# INTEROFFICE CORRESPONDENCE

COMMENTS ON ENVIRONMENTAL RESTORATION PROGRAM FOR OPERABLE UNIT

NUMBER 2

I would like to suggest several changes and modifications to the <u>surficial soil program</u> proposed in the final draft of PHASE II RFI/RIFS WORK PLAN.

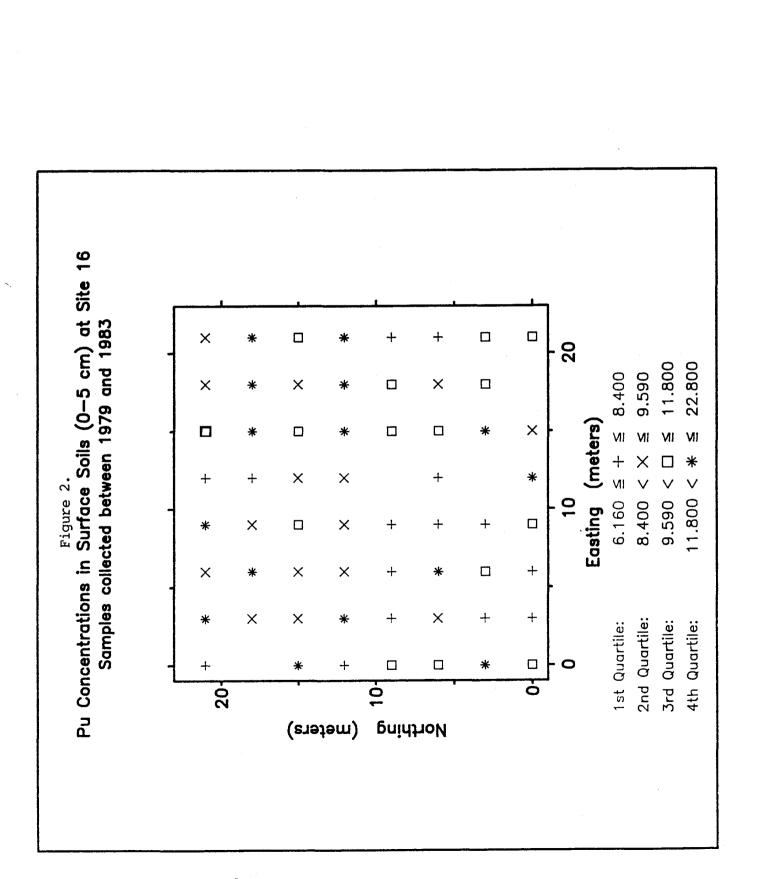
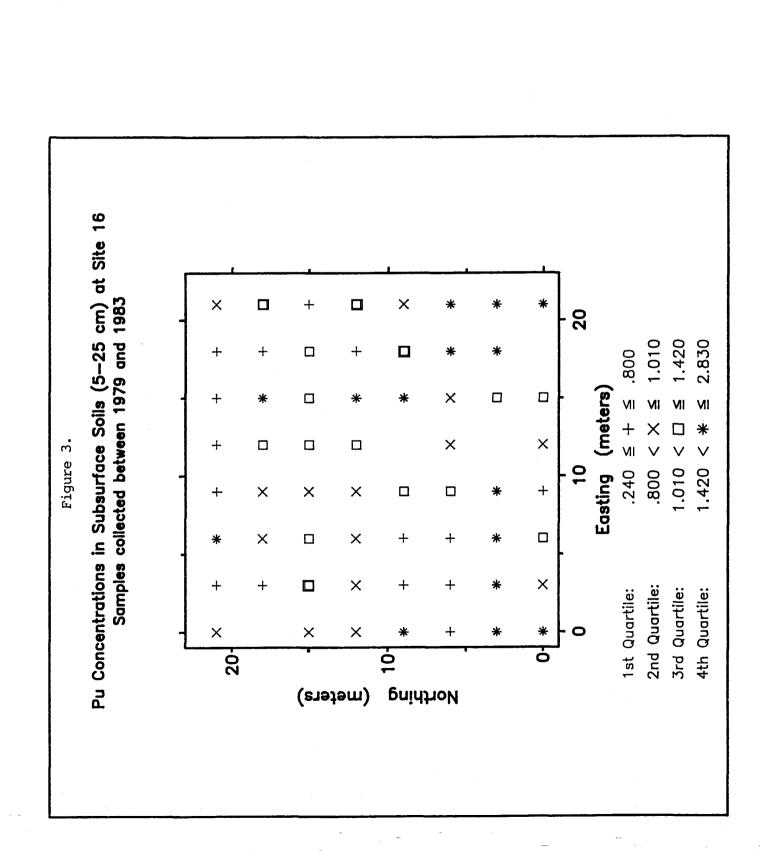
The spatial variations in Soil-Pu concentrations in site 16 are illustrated in Figures 2 and 3. There is no clear spatial trend in the concentrations of Soil-Pu in both depths. Indeed, analysis of the spatial variations of Soil-Pu within this site failed to produce a meaningful variogram (Fig. 4; Variogram measures the degree of correlation among sample values in a given area as a function of the distance and direction between samples. These values are later can be used for estimation of kriging weights). The results of the variogram suggest that the Soil-Pu values are spatially independent from each other or were randomly distributed. In reality, the grid size was too small for a meaningful evaluation of the spatial pattern of Soil-Pu in soils around RFP.

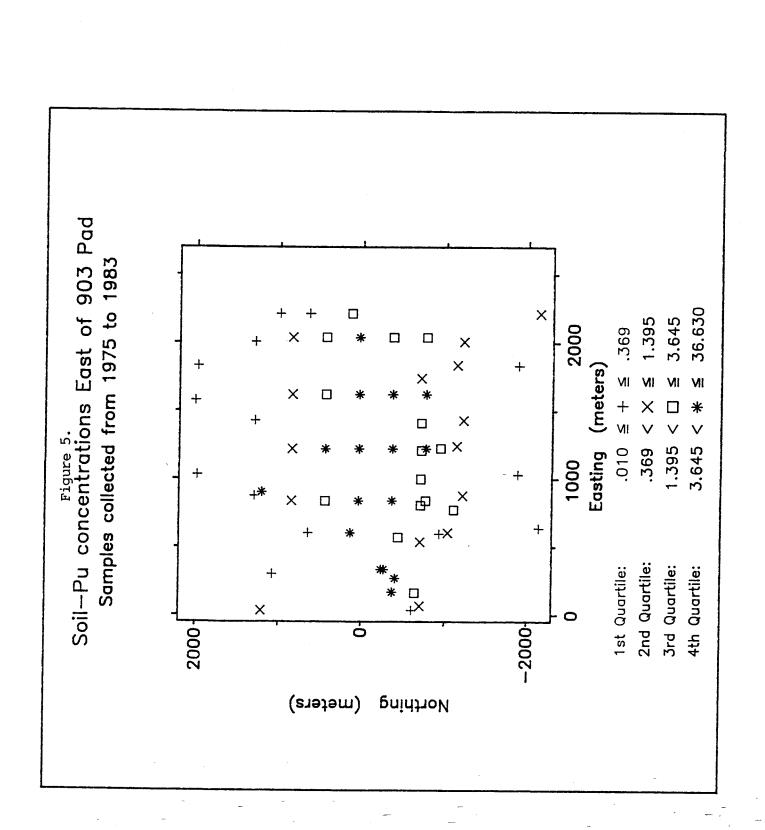
The extensive study sites are located east of the 903 Pad (Figs 1 & 5). The concentrations of Soil-Pu depicted in Fig. 5 clearly suggest a spatial trend from west to east. The variogram computation suggests a linear model with no sill or range and a nugget (systematic change over distance) of 0.75 (Fig. 6). The most commonly used variogram models in geochemical application are the spherical and exponential models. These models imply that there is a measurable distance or barrier that controls the spatial distribution of a given element. The findings that the concentrations of Soil-Pu in surface soils east of RF are best described by linear model with no actual limit on spatial dependency suggest that wind is the most probable force that control Pu transport across the landscape. Kriging estimates using the linear model were computed for the extensive study sites and are depicted in Figures 7, and 8. Figure 7 depicted contours of Soil-Pu concentrations in the buffer zone east of 903 Pad. Figure 8 illustrated the kriging standard of error estimates which are low in the west-east direction, which verified the goodness-of-fit of the kriging estimates in this direction.

The highest estimate of Soil-Pu concentration was found 500-600 meters east of 903 Pad which may resulted from storage practices of radioactive waste in the east trenches area. <u>More soil</u> samples around the east trenches area are needed to verify this hypothesis.
